# Red Hill Bulk Fuel Storage Facility, Oahu, Hawaii

September 7, 2022 Defueling Plan Supplement 1.A

1. *General Comment (Table 1, Pages 6-9): In Paragraph 4 of Section 11, Order, of the EO, DOH identified a minimum of seven (7) elements to be included in the Plan. The DoD Plan indicated that all the elements were either "partially complete" or "ongoing." We understand that much of the additional information and details such as defueling procedures, infrastructure repair design, and schedule will be completed on August 31, 2022, with the submission of the detailed Plan in September 2022. Address the following listed comments and include components related to the described unpacking process and Aqueous Film Forming Foam (AFFF) drain line repair. We look forward to receipt of the detailed Plan.*

Figure 1- Red Hill JP-5 Pipeline

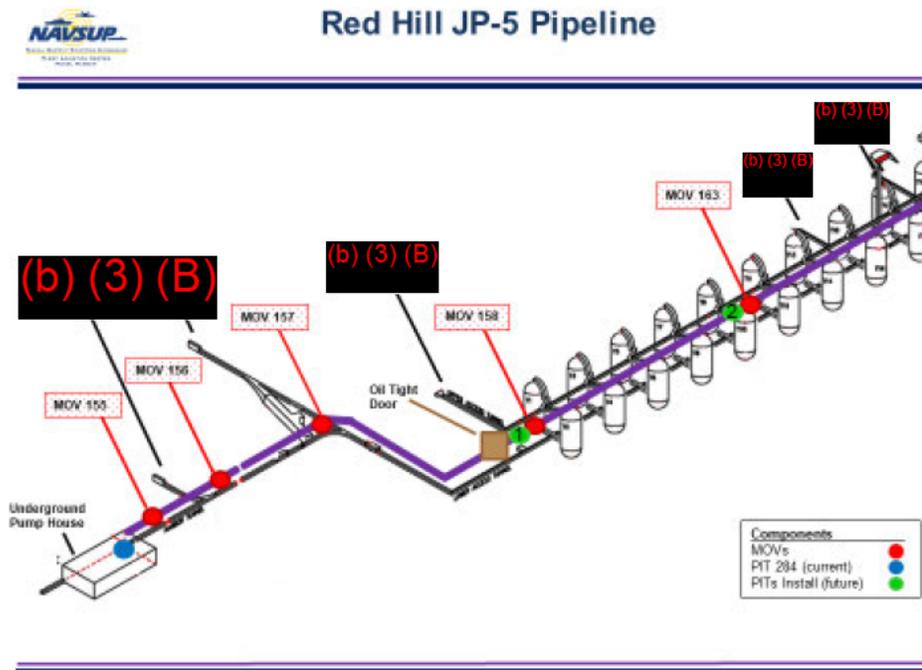
- a. *Page 2 states, "All three product pipeline systems contain some fuel, and some of the infrastructure repairs (e.g., JP5 [sic] pipeline repairs, installation of Pressure Indicator Transmitters (PITs), etc.) cannot commence until those lines are unpacked." However, Page 15 states, "To enhance safety of the unpacking process, DLA is contracting for 14 additional Pressure Indicating Transmitter sensors. These sensors go into all three fuel lines to provide continuous reading of the pressure in the pipe and would allow the operators to detect in real time and address any pressure anomalies during operations." Will the unpacking*

occur to allow for the pressure indicating transmitter sensors to be installed, or can they be installed safely with fuel in the system for the purpose of unpacking for other repairs? Provide information on the planned location of these 14 PIT sensors. Confirm that the Pressure Indicator Transmitters are the same as the Pressure Indicating Transmitter sensors.

**Response:** The Pressure Indicator Transmitters mentioned are synonymous with Pressure Indicating Transmitters (PITs). DoD must remove fuel from the pipelines prior to installation of the PITs.

DoD plans to install two additional PITs on the F-24 pipeline in the tank gallery and three additional PITs on the JP-5 pipeline in the tank gallery. DoD plans to forego using the F-76 pipeline and will instead use the JP-5 pipeline to transfer fuel out of the tanks containing F-76. DoD will inspect the pipelines out of the two F-76 tanks to confirm that they are still in good condition before defueling them using the JP-5 pipeline.<sup>7</sup> New PITs on the F-24 line will be located on the main pipeline downstream of the sectional valves near Tanks 1/2, and at the end of the line near Tanks 15/16. PITs on the JP-5 pipeline will be located on the main pipeline downstream of the sectional valves near Tanks 1/2, below the isolation valve near Tanks 10/11, and at the end of the line near Tanks 19/20. See the below schematics in figures 1 and 2.

The CPM schedule shows installation of all PITs by January 2023. DoD has amended its initial plan to install 14 PITs, reducing the number of PITs to five. It has done so for two reasons:

- 1) DoD has elected to forego repairs on the F-76 pipeline and instead use the JP-5 pipeline to transfer fuel out of the two F-76 tanks at RHBFSF. Doing so eliminates the need to make repairs on the large 32-inch diameter pipeline and eliminates the need to install PITs on that pipeline.
- 2) DoD has elected not to install PITs near the UGPH. Installing these PITs would not provide significant additional information about vacuum conditions and thus would not provide a safety benefit.
